Received
WILLIAMSON COUNTY, TEXAS
CHANGE ORDER NUMBER: 242018

Project: 1706-168
Inner Loop
Roadway: Improvements
Round Rock

Inner Loop Improvements Williamson County Project No. 1706-168

Change Order No. 2

REMOVAL PLAN

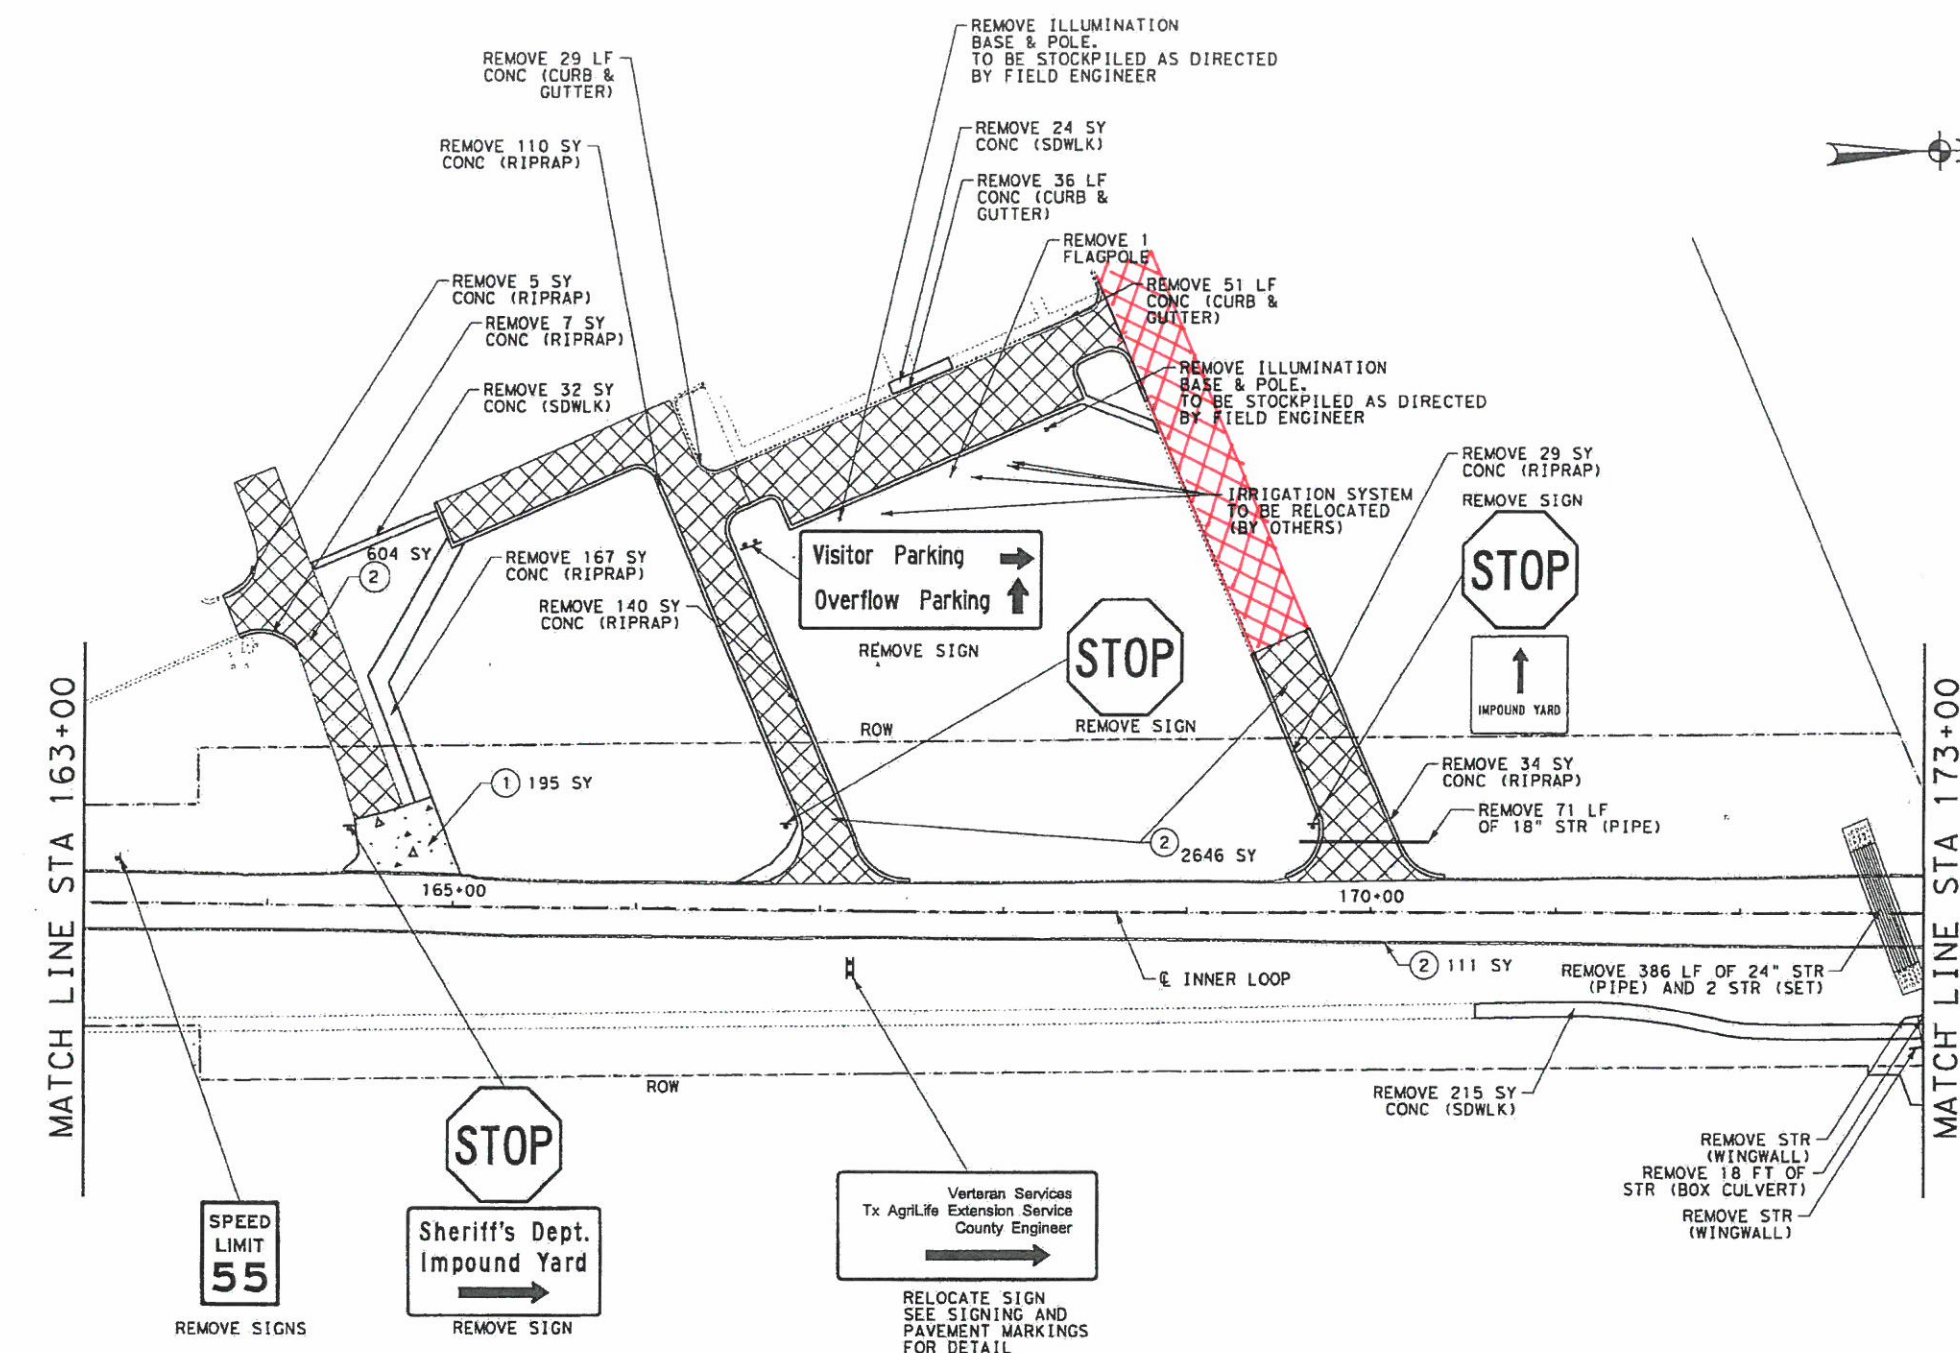
104-6022 REMOVE CONC (CURB & GUTTER) ADD 89.00 SY
 105-6036 REMOVE STAB BASE & ASPH PAV (15"-20") ADD 860.00 SY

**GEORGETOWN INNER LOOP
 CENTRAL MAINTENANCE FACILITY
 ROADWAY
 PLAN & PROFILE**

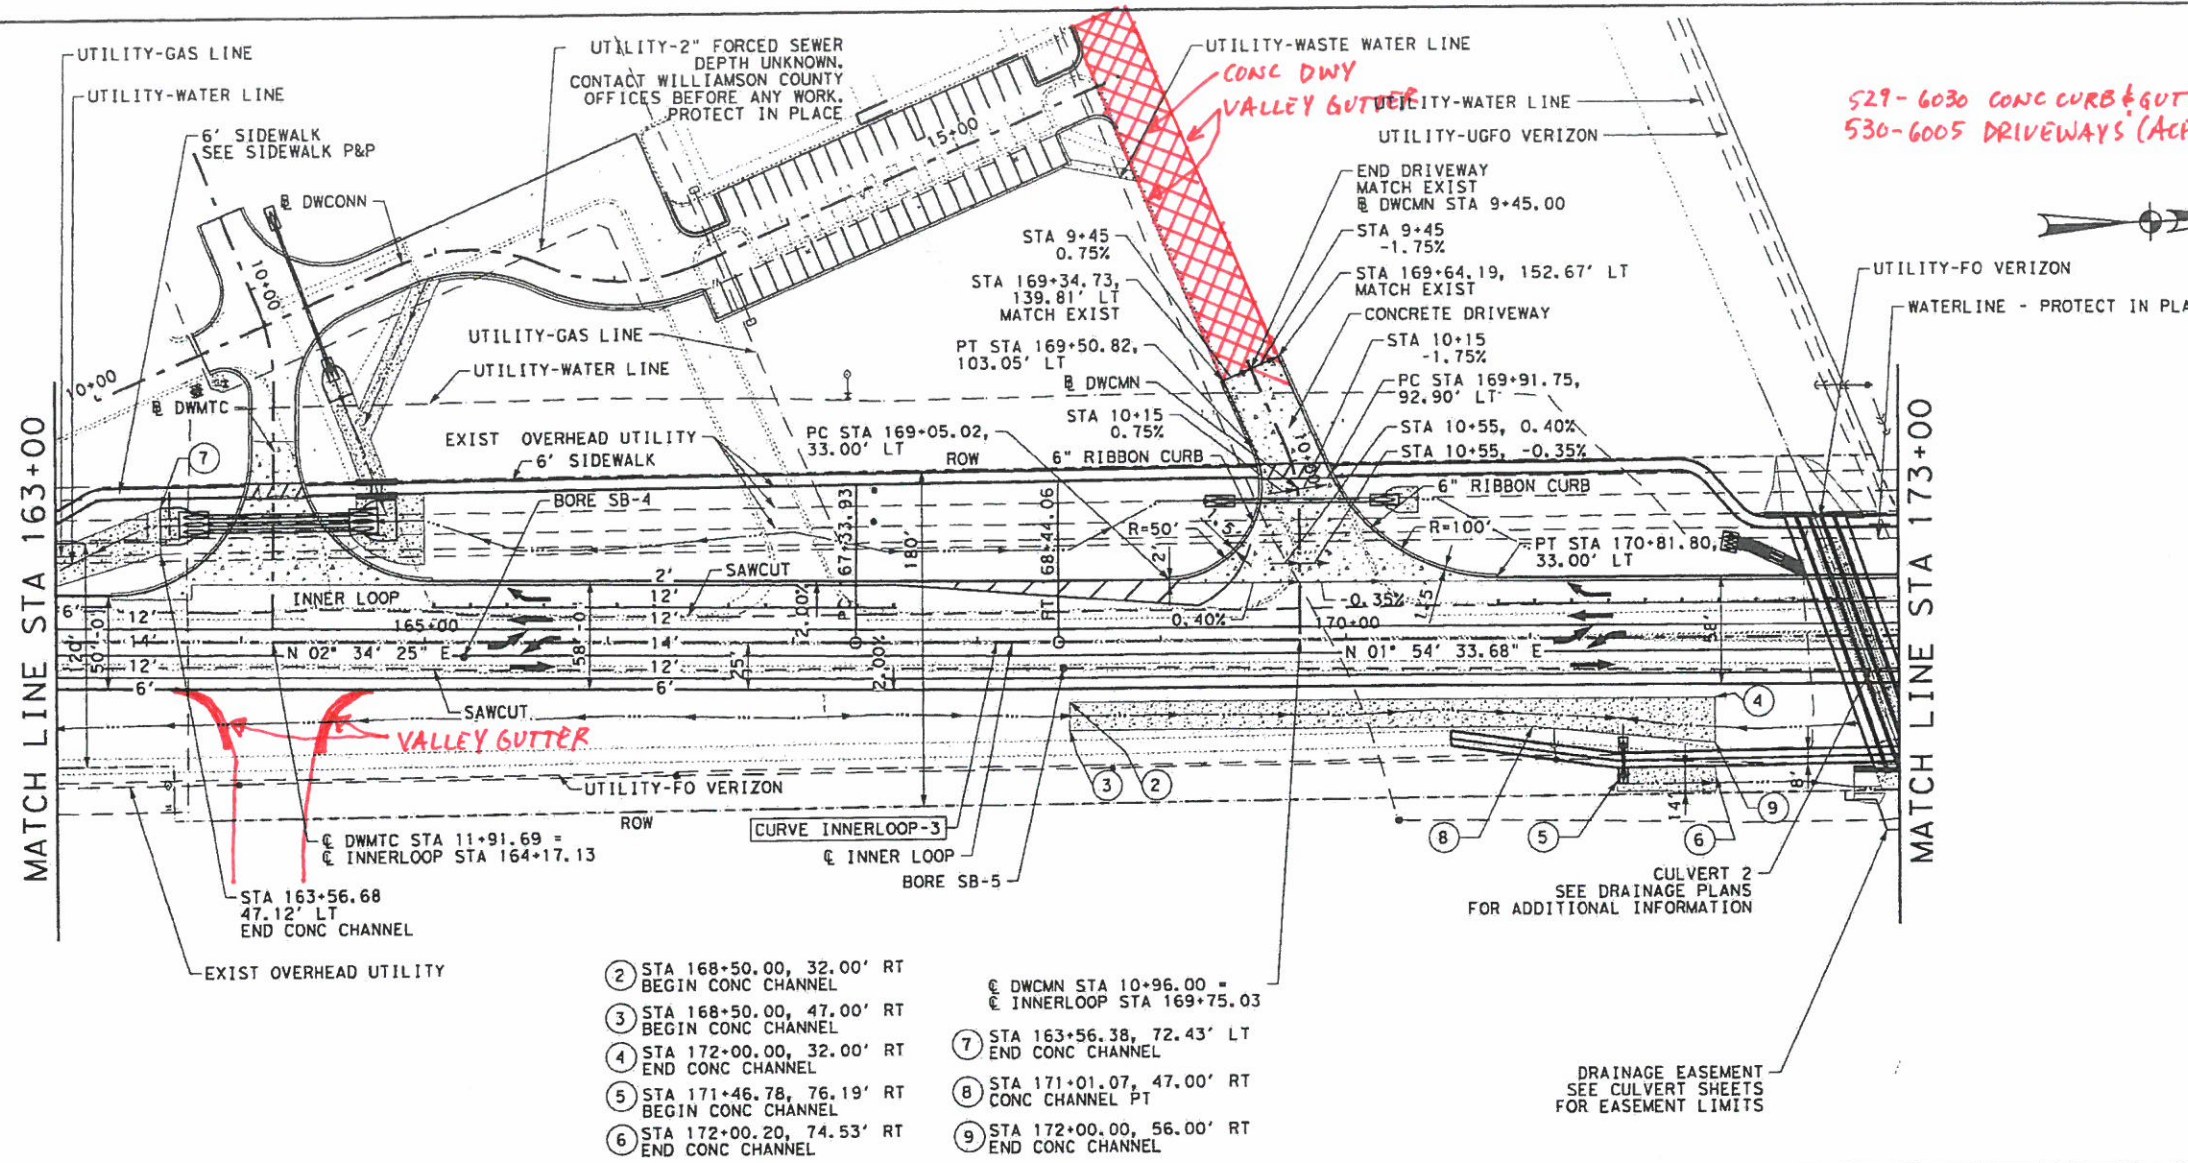
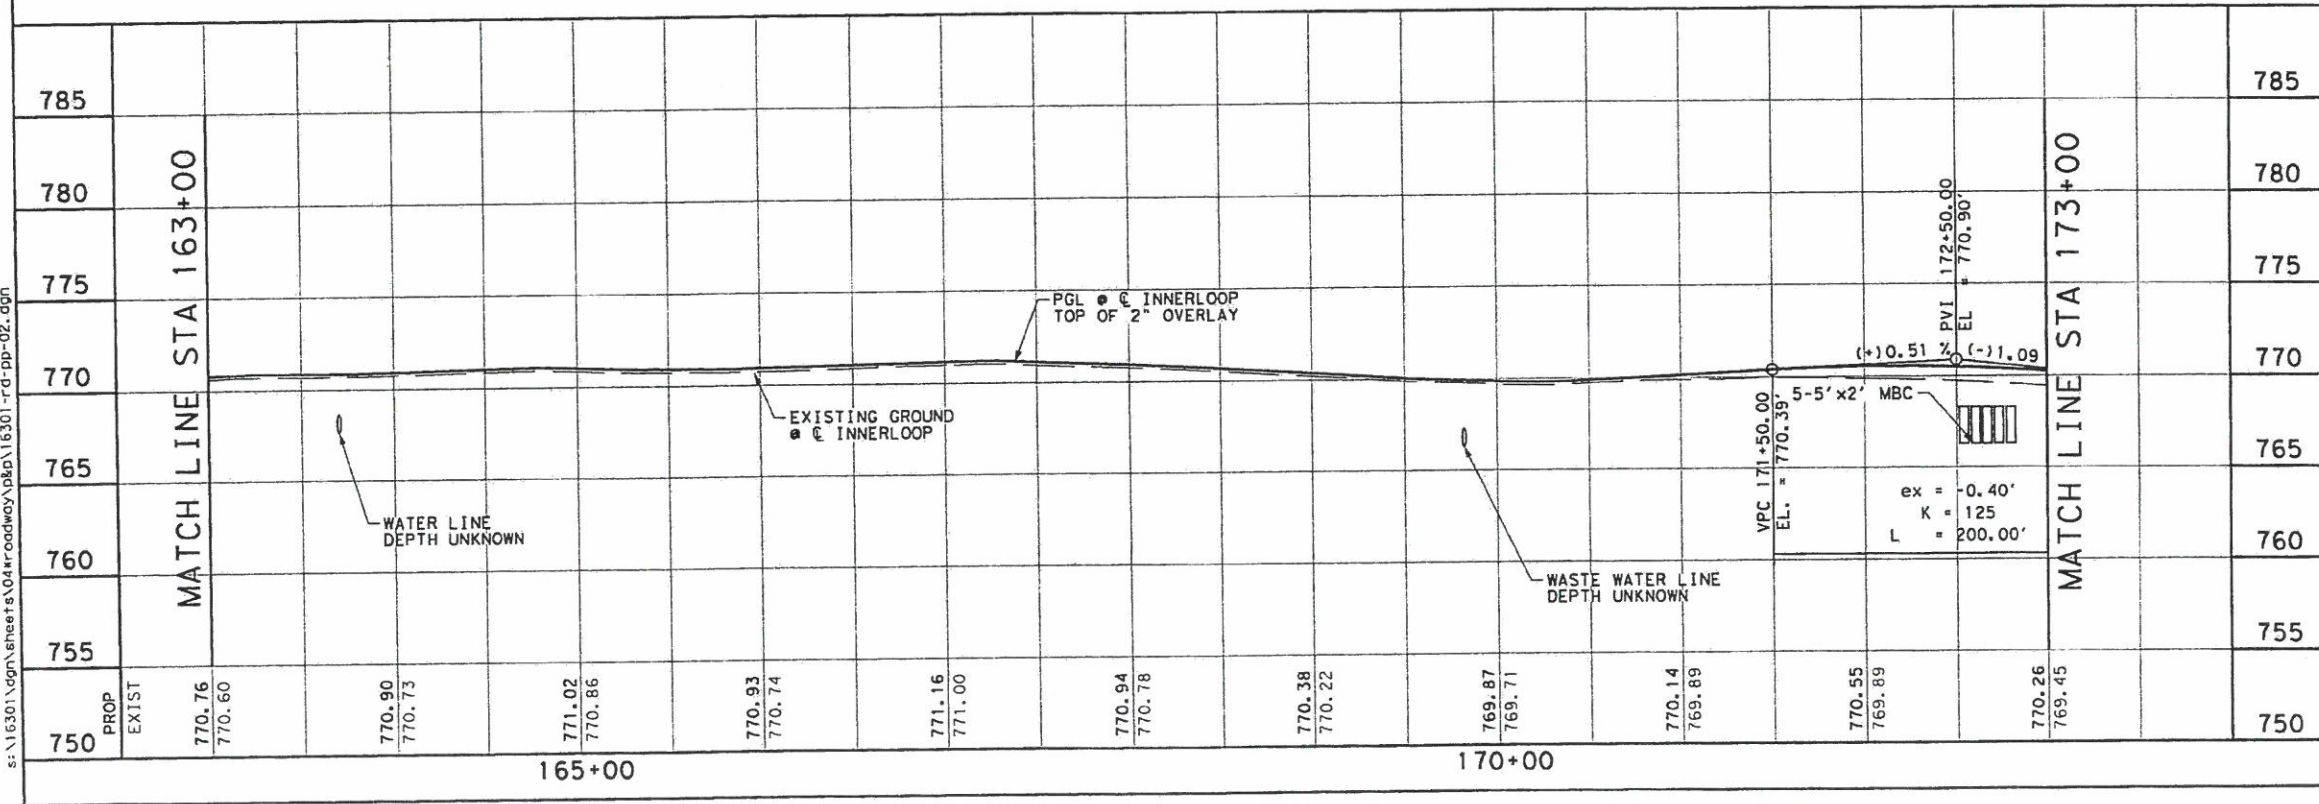
529-6030 CONC CURB & GUTTER (VALLEY GUTTER) ADD 860.00 SY
 530-6005 DRIVEWAYS (ACP) ADD 470.00 LF
